Council File No: 22-0163

**Re: 464-466 Crane Boulevard Project - Failure to Provide Notice
May 2, 2023 PLUM Meeting Item # 10, CF No. 22-0163**

Comment for the PLUM hearing for ENV-2020-428-CE

Original Plans

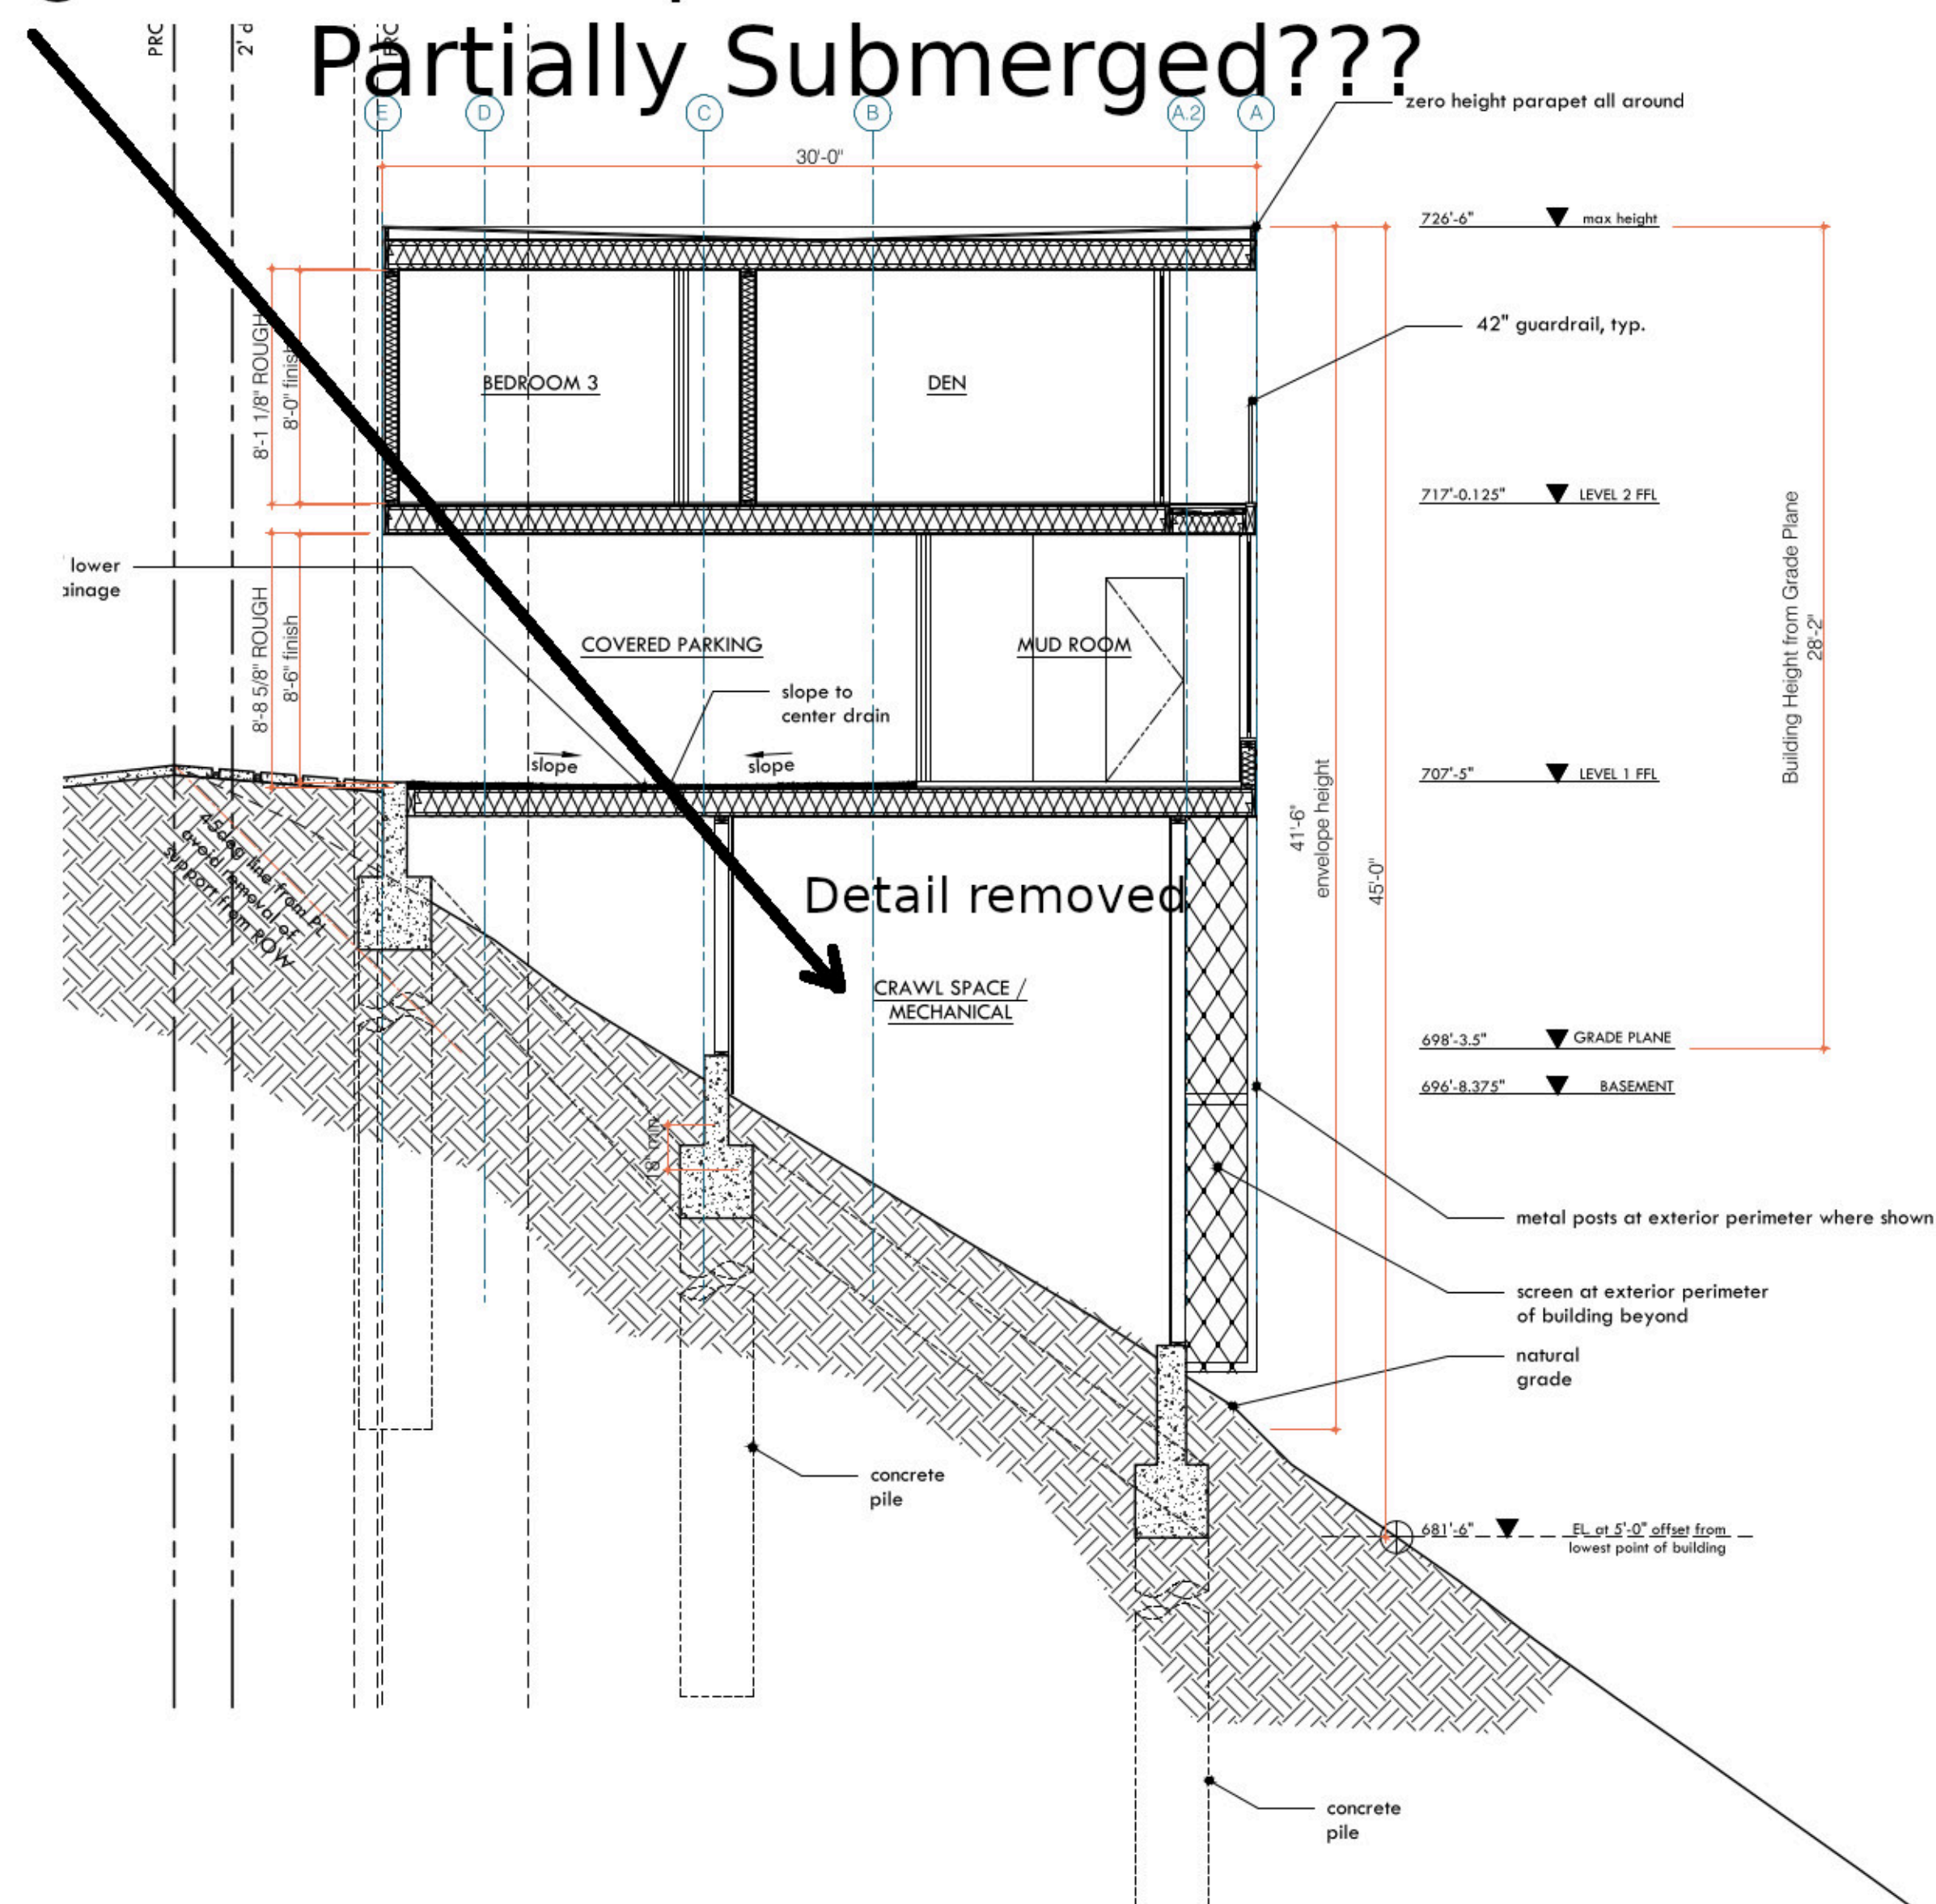
Plans have been intentionally changed to hide the fact that the lowest level is a Story

See the attached selections taken from the project plans. The two at the top are from the original plan and the two at the bottom from the updated plans. You will note that art studio has been relabeled as a mechanical room **BUT** in actuality it will function as whatever the eventual owners will wish it to be. One might think that only a dolt could or would think otherwise, I couldn't say.

Note, the 8'-6" dimension and floor detail that has been deleted. But also, note the floor detail on the floor plan remains – because of course there will be a floor, an enclosed room (which from other details on the plans will have a window, a normal door to “crawl” through (i.e. walk through like a normal person), and have a lovely covered desk surrounding the art studio (oops, a mean mechanical room) with its lattice walls (with dappled sun light filtering through. Sounds nice for a partially submerged, crawlspace, basement.

Per LAMC the lowest level is a Story not a basement, both Planning and the Applicant know this!!

Magically becomes mechanical

8'-6"
Height

Crawl space??
Partially Submerged???
